**TOWN OF NEWBURGH
PLANNING BOARD
TECHNICAL REVIEW COMMENTS**

PROJECT: FARRELL INDUSTRIAL PARK
PROJECT NO.: 20-16
PROJECT LOCATION: SECTION 1, BLOCK 1, LOT 92.42
REVIEW DATE: 11 DECEMBER 2020
MEETING DATE: 17 DECEMBER 2020
PROJECT REPRESENTATIVE: JMC ENGINEERING/JOSEPH P. MCDAFFERI

EXISTING CONDITIONS MAP AND SITE REMOVALS PLAN
FARRELL INDUSTRIAL PARK
TOWN OF NEWBURGH, NY

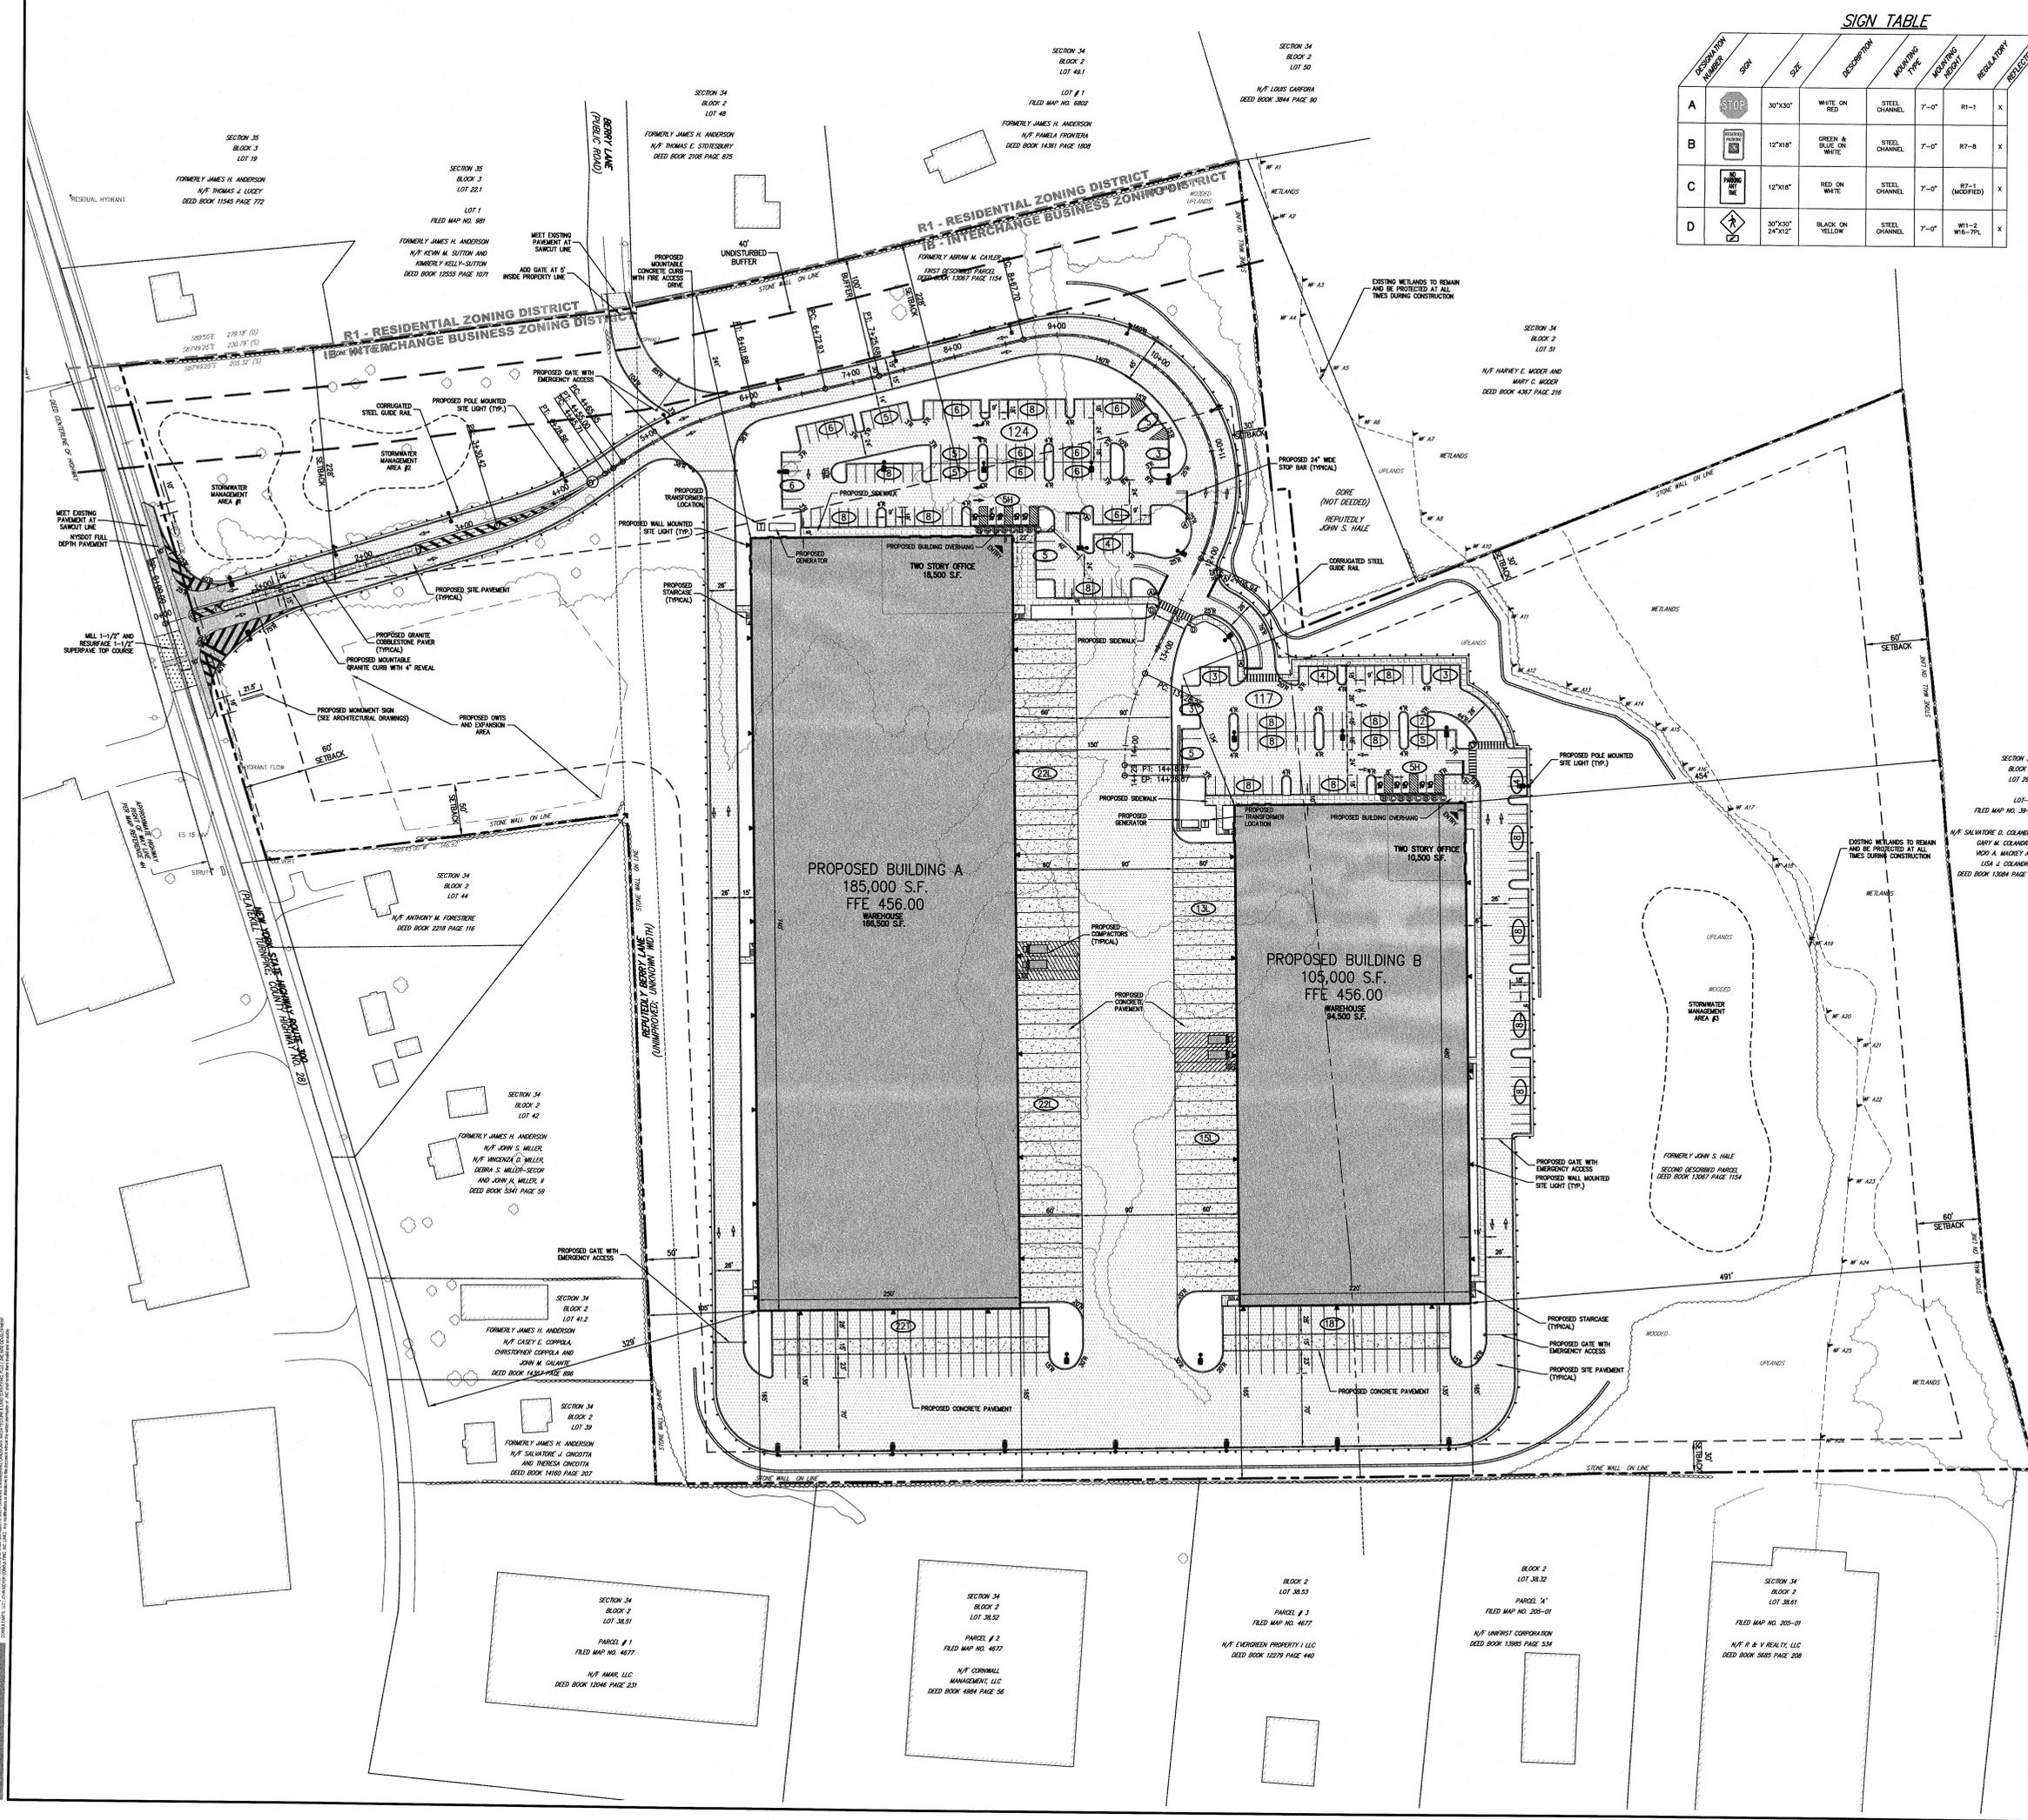
11. Note 2 on sheet C-010 identifies a wetland delineation. The Wetland Delineation Report should be submitted for the Planning Board's files.
12. The Geotechnical Report identified on Note 3 sheet C-010 should be submitted for the Board's use.
